Re: DRMS Permit Finalization

EXHIBIT L Reclamation Costs

DRMS Mining plan Map - Finalized.pdf 8251K

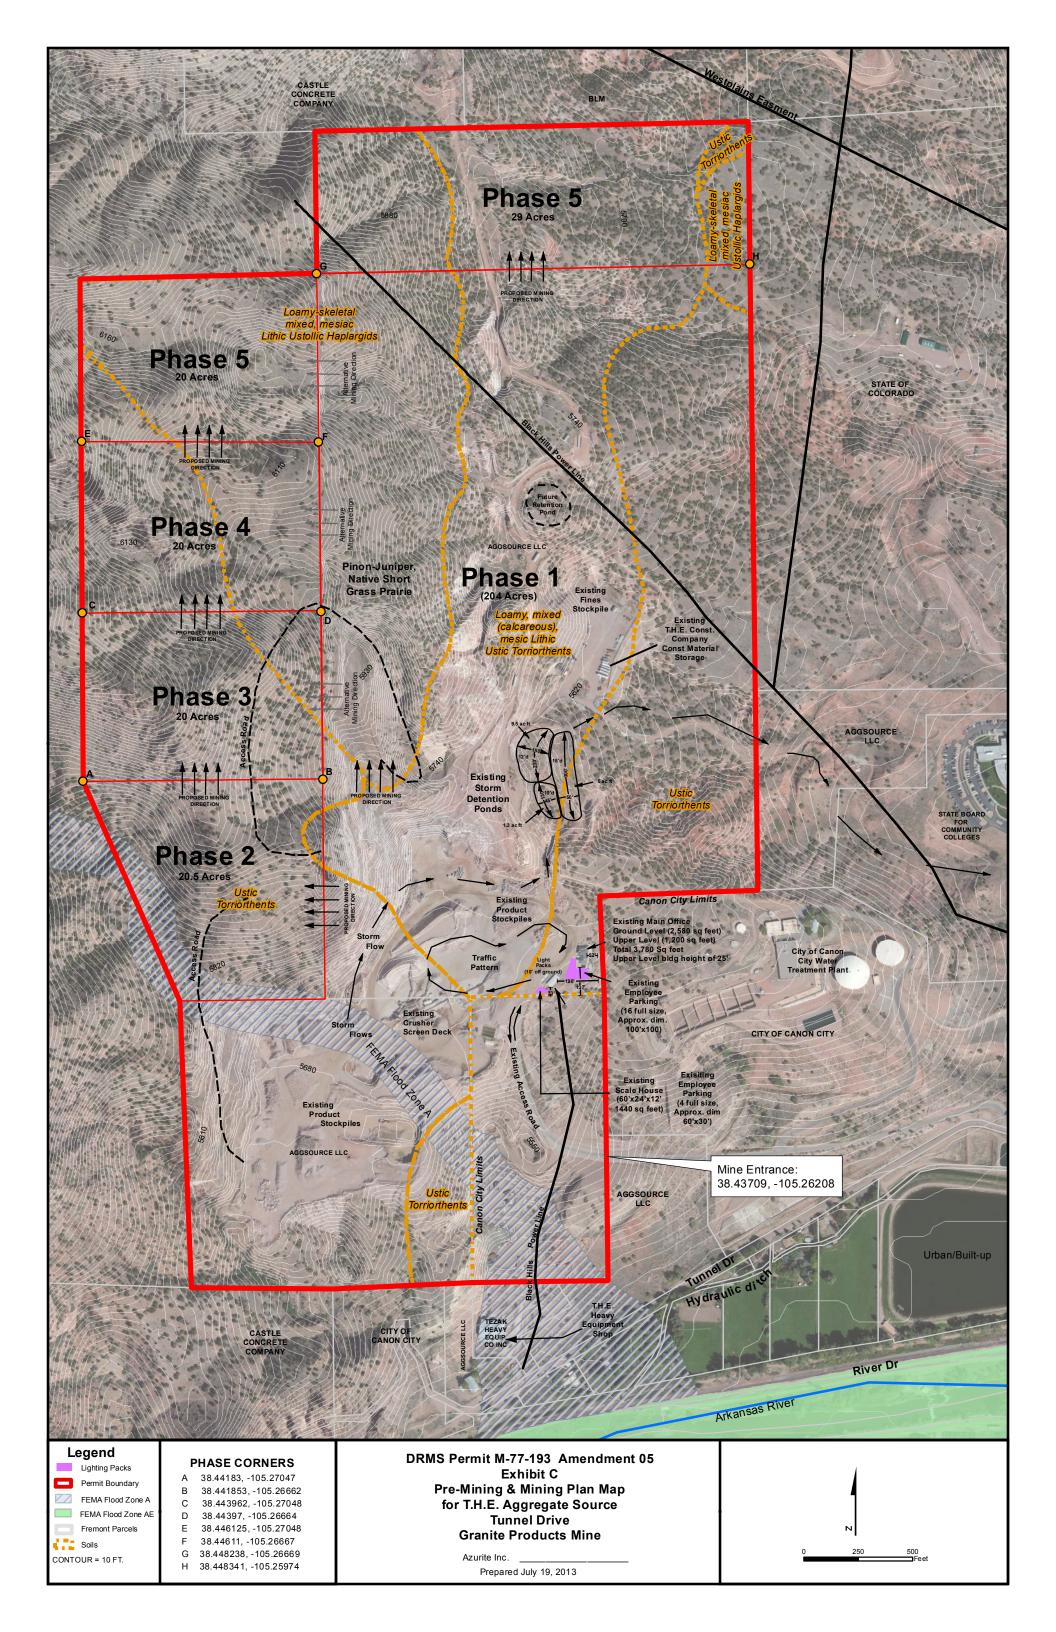
Attached is the revised map with "Direction of Mining Arrows" on Phase 1. Look it over and let me know if everyone is good with it and I'll have Ken Finalize.
